Re: Site Specific Investigation
Upland Heights Block 3 Tract A
Technical Review

This letter serves to present the findings of our technical review of the site specific investigation prepared by Trihydro Corporation (Trihydro) for the City of Laramie for the City owned Upland Heights Block 3 Tract A parcel of land located within the Casper Aquifer Protection Area. Our review comments will be presented to address the adequacy of this site specific investigation in fulfilling the requirements of the City of Laramie's Unified Development Code, subsection 15.08.040.A.8.

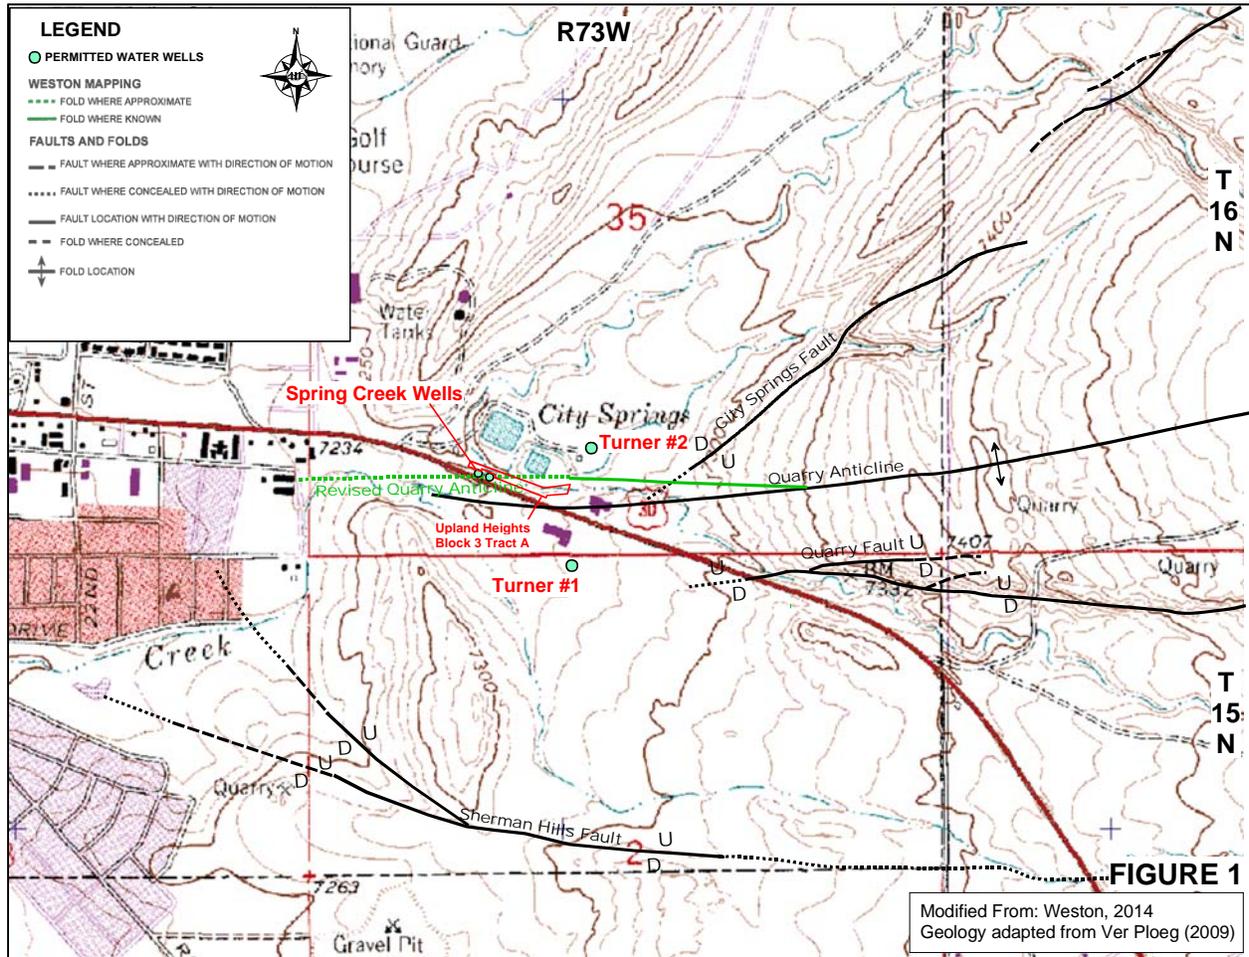
One item that was researched and discussed in later sections of Trihydro's SSI, but not listed in this section of their report, were the State Engineer's Office completion records for the wells in the subject property area. A review of the statement of completion records for the two Wyoming State Highway Department wells (Spring Creek Well Nos. 1 and 2) located immediately to the south of the study site reveals that "fractured zones" were encountered at depths below approximately 20 feet. The reference to fracture zones in the nearby wells is evidence that conduit flow could be present in the area of the Upland Heights Block 3 Tract A parcel. The locations of the Spring Creek wells are shown in the figure on the following page.

The Trihydro SSI report accurately identifies the nearby wells as: 1) the City of Laramie Turner #2 well (U.W. 55508); 2) WYDOT's Spring Creek #1 well (U.W. 69160); and 3) WYDOT's Spring Creek #2 well (U.W. 69161). Only the location of the Turner #2 well is shown on Figure 1 even though the SSI report text indicates that all three of these wells have been shown on this figure. Also, the description of the location of the Spring Creek wells is in error. The SSI report describes these wells as being located north of the subject property when they are actually located on the south side of Upland Heights Block 3 Tract A parcel on the east and west side of the Grand Avenue bridge that crosses Spring Creek (northeast and northwest abutments). A review of the Wyoming State Engineer's Office records also shows that the City of Laramie Turner #1 Well (U.W. 55507) is also located less than 1,000 feet from the Tract A parcel. The locations of these nearby wells have been shown in the figure on page 3 of this letter report.
